UNITED STATES OF AMERICA
NUCLEAR REGULATORY COMMISSION

In the Matter of)
PHILADELPHIA ELECTRIC COMPANY) Docket Nos. 50-352
(Limerick Generating Station) 50-353
Units 1 and 2)

TESTIMONY OF REX G. WESCOTT CONCERNING THE
IMPACT OF BRADSHAW RESERVOIR
ON GROUNDWATER RESOURCES

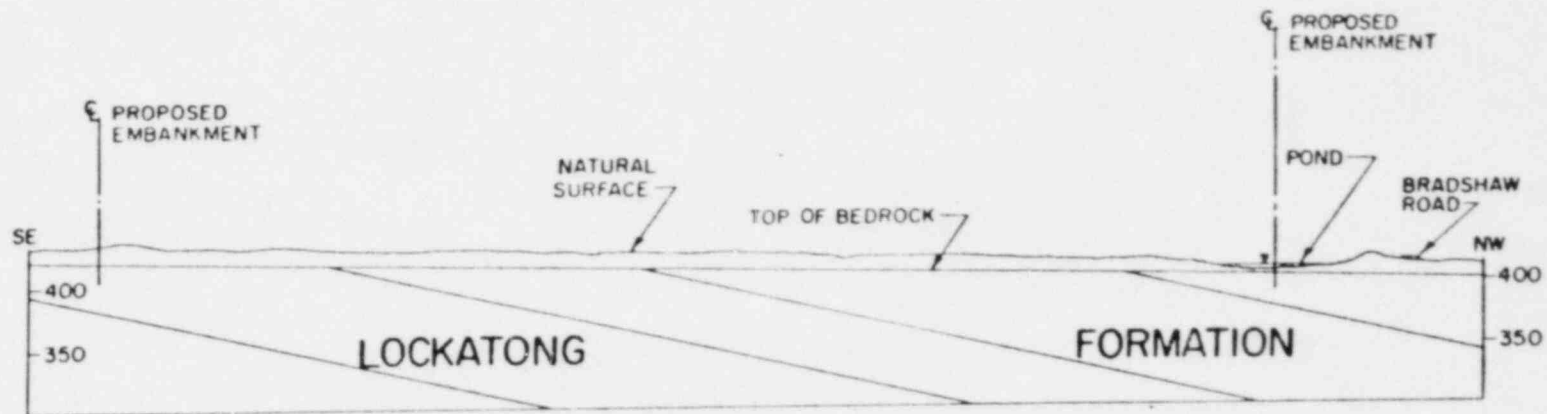
A6. Yes, I have made an independent calculation using the reservoir dimensions and volume as shown in the applicant's reports and drawings and have calculated approximately the same seepage rate.

A7. Yes, I took no credit for the relatively impermeable material underneath the reservoir which would lower the assumed gradient and significantly reduce the calculated seepage.

$$Q = K i A \quad i = 13.4 \div 2 = 6.7 \text{ ft/ft}$$

$$= 0.014 \times 6.7 \times 620,000$$

$$= 58,156 \text{ cu. ft / day}$$

$$= 436,170 \text{ gpd} = 0.67 \text{ cfs}$$

Note - This will be a conservative estimate as it assumes free flow under lining, with no back pressure. Pond on site with relatively constant level indicates very limited flow thru overburden or thru underlying weathered rock

FIGURE E 240.24-5

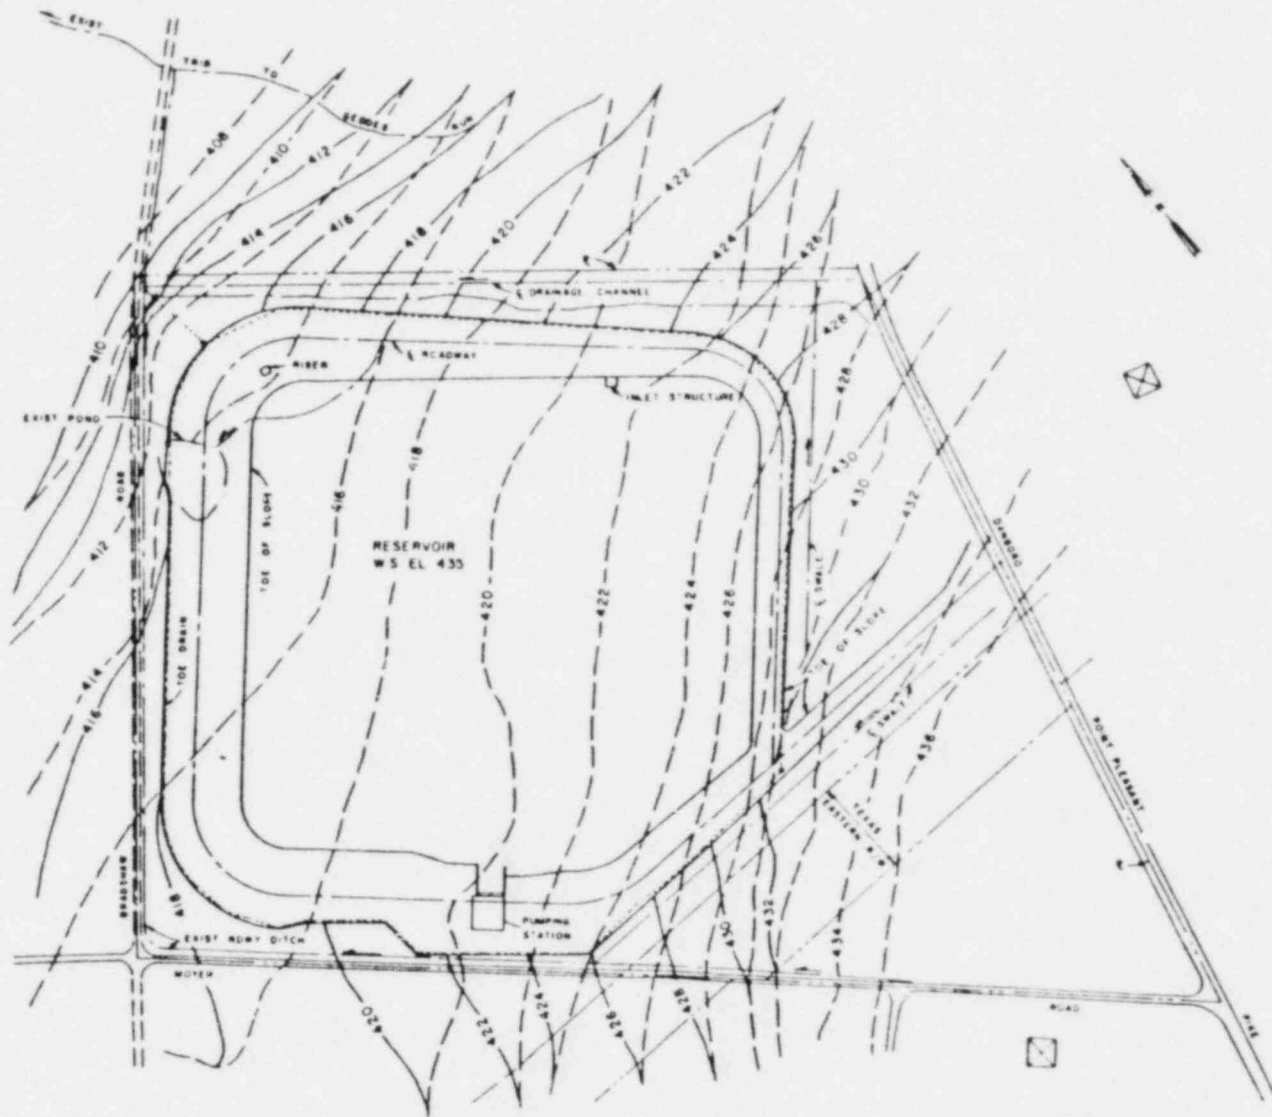
A11. In response to my question E 240.24 the applicant provided a map showing the expected rise in the present groundwater level due to seepage from the reservoir and the resulting groundwater gradients. The map of existing and expected post construction water table contours (Figure E 240.24-5 of Exhibit 1) shows a groundwater mound approximately 3 ft above the present ground water level adjacent to the reservoir tapering off to the present level approximately 400 ft from the reservoir. The direction of flow as shown by the groundwater level contours is toward the Northeast.

A14. According to the applicant's groundwater level map, all nearby wells are upgradient of the reservoir, i.e., in the opposite direction to the direction of groundwater movement.

- e) Figure E240.24-5 shows the location of groundwater users near Bradshaw Reservoir; however, since they are located south of the reservoir and the seepage will flow to the north, they will not be affected. It has been concluded that there will be no reversal of the direction of groundwater flow, and there will be no new recharge to existing wells in the area.

PLATE 6

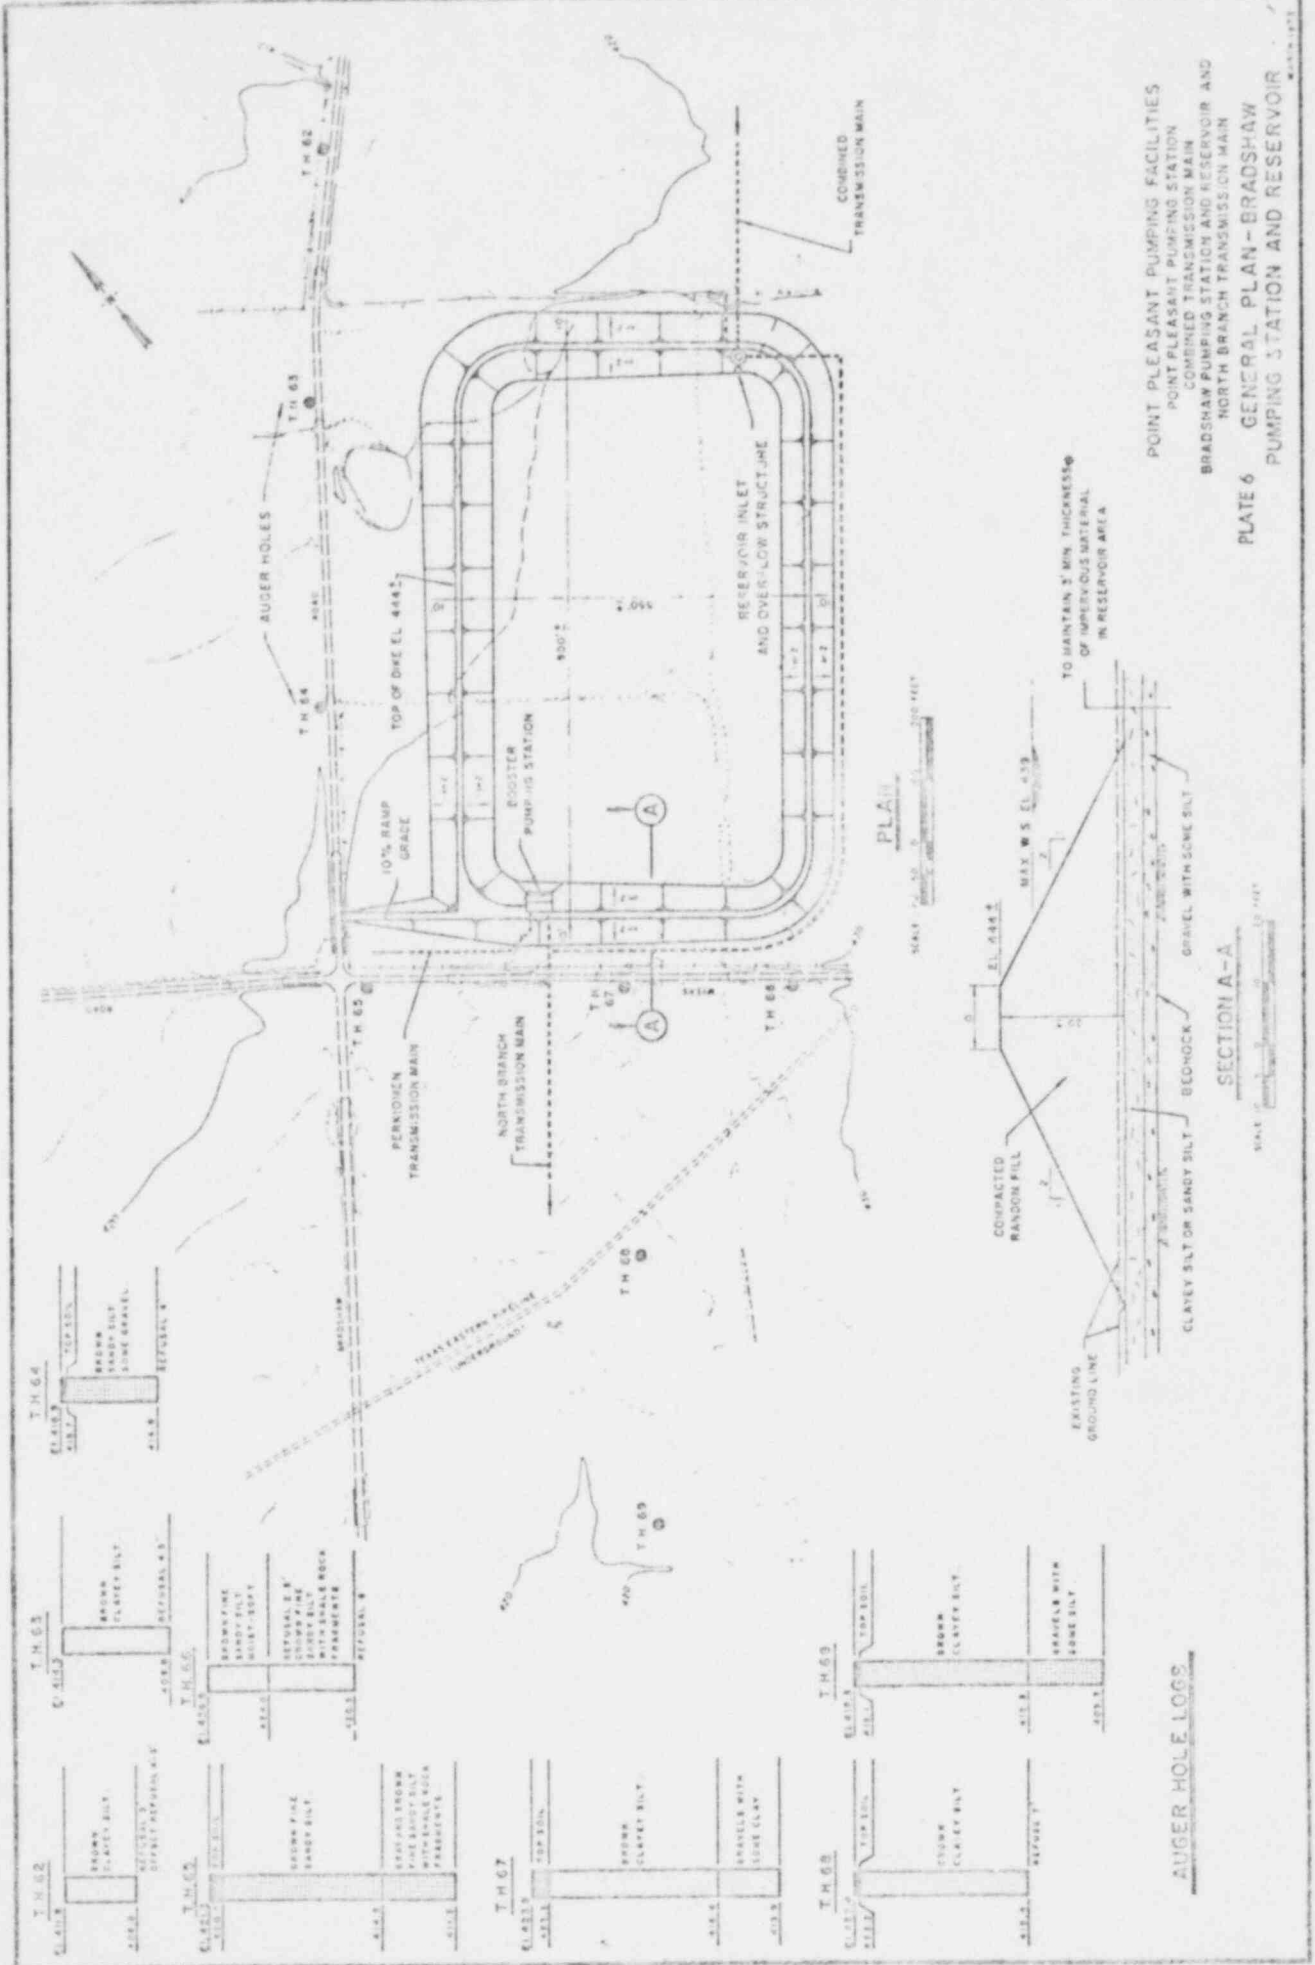
A16. The most detailed description of the original reservoir design that I have located is found on Plate 6 (Exhibit 4) of the Final Environmental Impact Statement - Point Pleasant Diversion Plan prepared by Delaware River Basin Commission dated February 1973.

Plate 6 shows the reservoir as being rectangular in shape, approximately 900 ft long and 500 ft wide (from top of dike to top of dike). The plate also shows 3 feet of impervious existing soil in the reservoir area and a maximum water depth of 15 ft. Drawings recently obtained from the applicant show the presently designed reservoir to be approximately 900 ft by 900 ft (top of dike to top of dike), an impervious liner of 2 ft and a maximum depth of 19 ft (Exhibit 1). The most apparent features influencing seepage rate would be size, water depth, and liner thickness.

A18. The original design showed the bottom of the reservoir as consisting of 3 ft of existing impervious soil with a layer of gravel underneath. The permeability of the existing soil as determined from laboratory permeability tests presented in the Supplemental Data and Information report by Bourquard (Exhibit 3) is approximately 5×10^{-5} cm/sec. This is ten times the permeability which will be guaranteed for the liner to be constructed in the presently proposed design. This factor of 10 more than offsets the increase in size of the reservoir and the reduced thickness of impermeable material.
